STATE OF ILLINOIS  
DEPARTMENT OF TRANSPORTATION

| ROUTE NO.             | SECTION  | COUNTY           | SHEET NO. | SHEET NO. |
|-----------------------|----------|------------------|-----------|-----------|
| FAP 595               | 1-3-K    | Rock Island      | 476       | 289C      |

**CONCRETE PARAPET  
SLIPFORMING OPTION**

Added 2-23-05

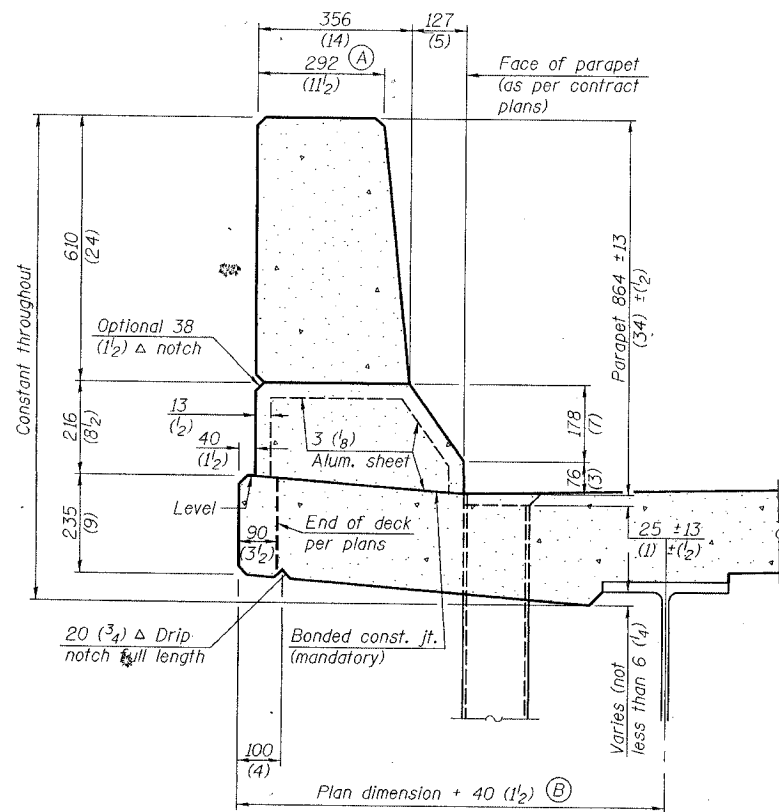
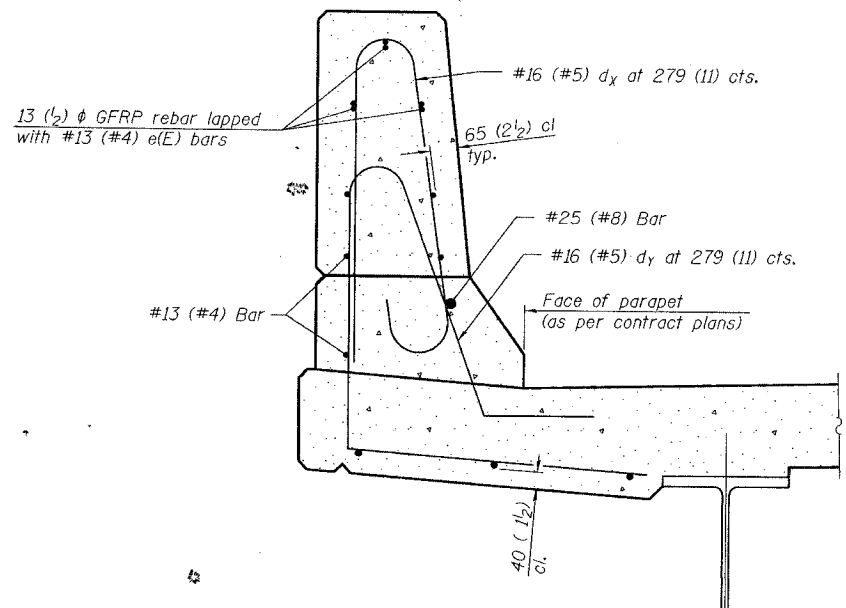
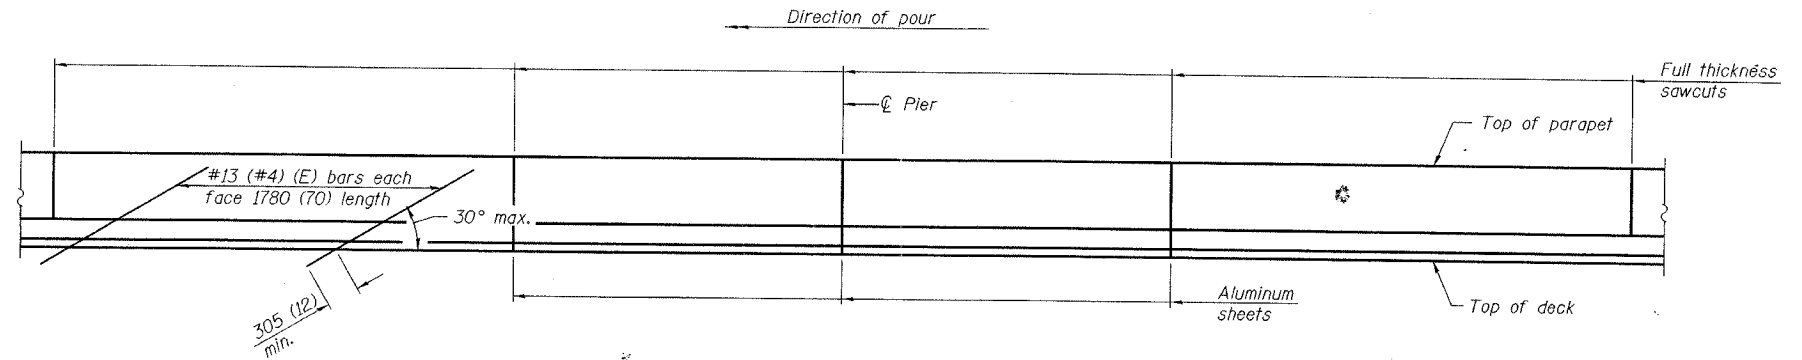
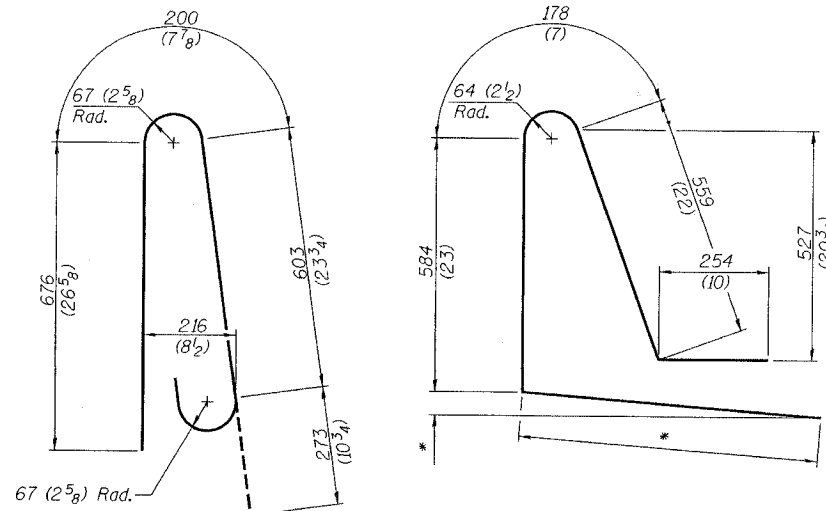
All dimensions shall remain the same as shown on contract plans, except dimensions A and B which are to be revised as shown to provide additional clearance. Additional concrete needed to revise dimension A and B= 0.0422 m<sup>3</sup>/m (0.165 cu. yds./ft.) of parapet. Place aluminum sheet in curb portion at and near piers. Full thickness saw cut at all other locations. Adjust/add joint locations to maintain 3 to 6 meter (10 to 20 foot) spacing.
